Regulation No. 80 (Strength of seats and their anchorages (buses))

Proposal for the 03 series of amendments

Submitted by the experts from Belgium and Germany*

Figure 1
Positioning requirements for side-facing seats

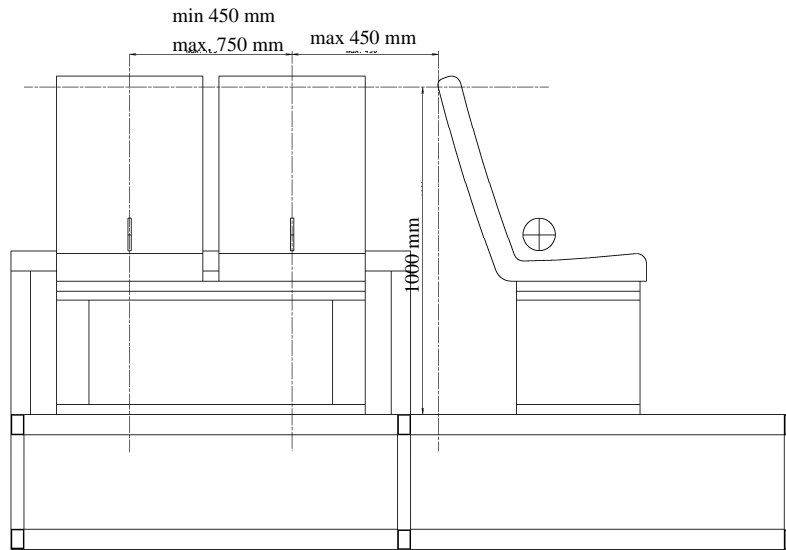
1. **The distance between the foremost side-facing seat and the vehicle part forward of this foremost side-facing seat shall not exceed 450 mm. All measurements are to be taken 1000 mm above the reference plane of the foremost side-facing seat (see figure 1).**

Figure 2
Positioning requirements for the vehicle part forward of the foremost side-facing seat

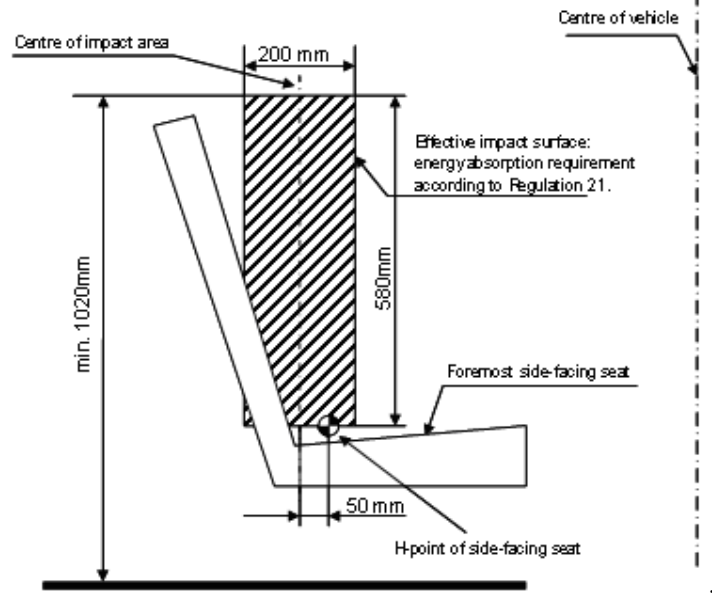
2. **The vehicle part (e.g. partition, wall or seat back of a forward facing seat) in front of the foremost side-facing seat shall fulfil the following requirements in order to safeguard the passenger in that foremost side-facing seat (see figure 2):**

- 2.1. **The height of the vehicle part, based on the reference plane of the foremost side-facing seat, must not be less than 1,020 mm; and**
 - 2.2. **the effective impact surface of the vehicle part has a width of 200 mm and a height of 580 mm. This surface shall be positioned so that the vertical centre-line is located 50 mm behind the H-point of the foremost side-facing seat; and**

- 2.3. **the corresponding surface of the vehicle part in place projected onto a vertical plane through this H-point, shall cover at least 95 per cent of the effective impact surface. This vehicle part shall fulfil the energy absorption requirement by Appendix 6.**

- 2.3.1. **If there is a gap in the corresponding surface (typically two forward-facing seats with a gap in between) a distance shall be determined for**

each gap by means of a sphere having a diameter of 165 mm. The sphere shall be put into contact with the gap in a point of the gap area which allows the maximum sphere intrusion, considering no load is to be applied. The distance between the two points of contact of the sphere must be less than 60 mm;

1. Arrangements in the approval mark for a seat

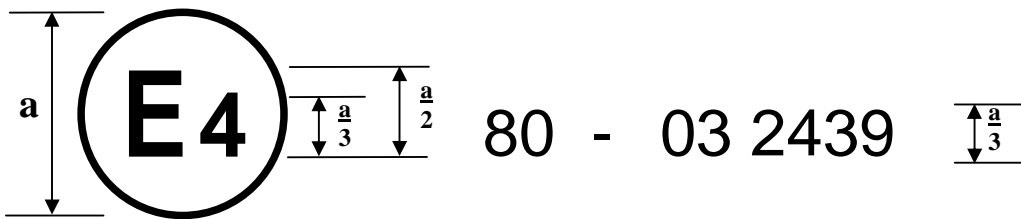
The above approval mark affixed to a seat shows that the seat type concerned has, with regard to the strength of the seats, the test being carried out in accordance with paragraph 2 of Annex 4, been approved in the Netherlands (E4) under number 022439. The

approval number indicates that the approval was granted in accordance with the requirements of Regulation No. 80 as amended by the **03** series of amendments.

2. Arrangements in the approval mark for a vehicle type

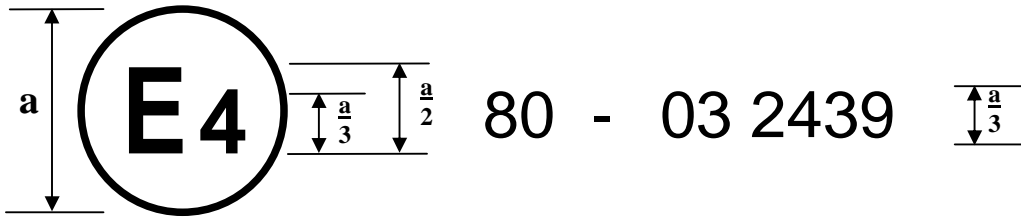
The above approval mark, affixed to a vehicle, shows that this type of vehicle has been approved in the Netherlands (E4) under number 022439 with regard to the strength of the anchorages on the vehicle. The approval number indicates that the approval was granted in accordance with the requirements of Regulation No. 80 as amended by the **03** series of amendments.”
